**STAFF REPORT  
WEST ALLIS PLAN COMMISSION  
Wednesday, March 22, 2023  
6:00 PM**

- 2A. Conditional Use Permit for Dunkin', a proposed Restaurant with accessory drive-through service, at 7801 W. Greenfield Ave.**
- 2B. Site, Landscaping, and Architectural Design Review for Dunkin', a proposed Restaurant with accessory drive-through service, at 7801 W. Greenfield Ave. (Tax Key No. 452-0566-000)**

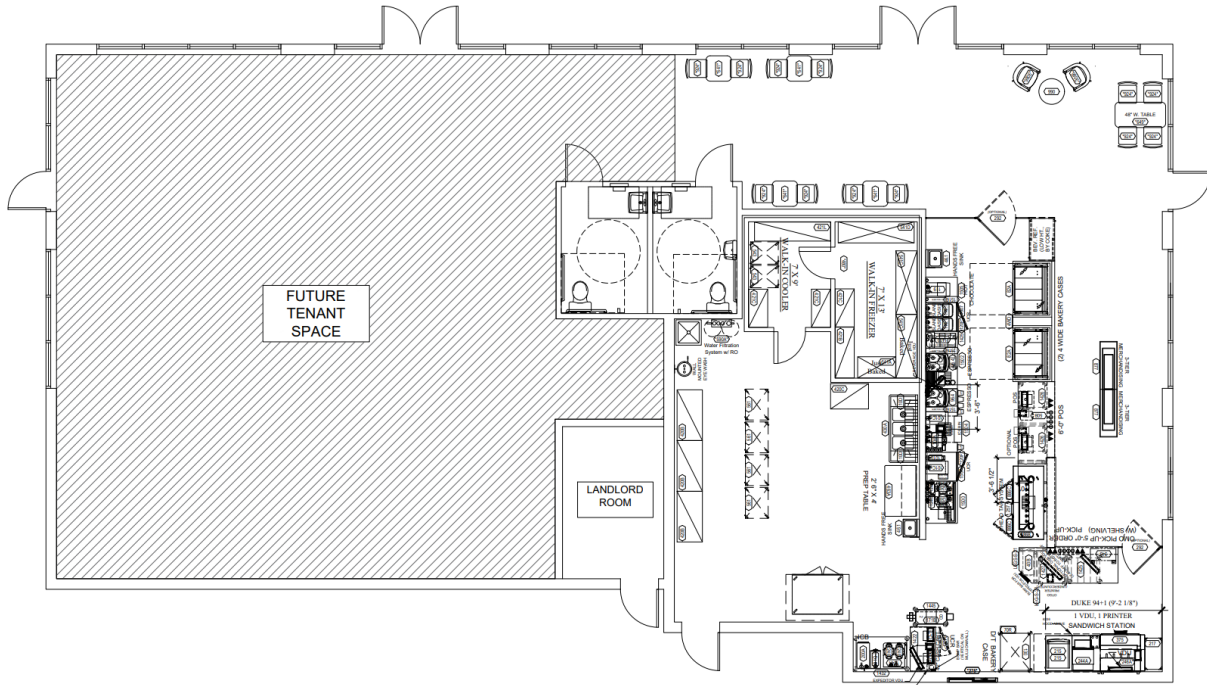
The proposed façade includes fiber cement panels (light grey), thin brick veneer (dark grey), EIFS (tan and accent colors), and metal banding. Staff advised the applicant that EIFS is not an accepted material; the applicant agreed to change EIFS to a higher quality material.

4 vertical elements in a different material (shown as EIFS in plans) frame the façade. 2 of these elements are located above the main tenant entrances on the front, 1 bookends the South end of the East side elevation, and 1 frames the drive-through service window on the rear. The East side vertical element is the only one that does not extend to above the parapet line. The front elements are slightly different, with Dunkin's dropping down to ground level around the entrance windows and the other tenant space solely above the middle metal banding.

- 3ai. Quality Materials: EIFS is not an accepted material due to history of poor performance.

The applicant has agreed to replace this with a higher quality material; at that point the project will satisfy all design guidelines.

1. Common Council approval of the Conditional Use Permit (scheduled for April 18, 2023).
2. Submit revised site, landscaping and architectural plans to the Planning & Zoning office to show the following: a) replace EIFS with higher quality building material; b) replace proposed pole sign on site plan with conforming freestanding sign base; c) removal of 2 parking spaces to comply with Sec. 19.44(2); d) addition of outdoor bike rack to comply with Sec. 19.44(3); e) landscaping planting plan approved by City Forestry.
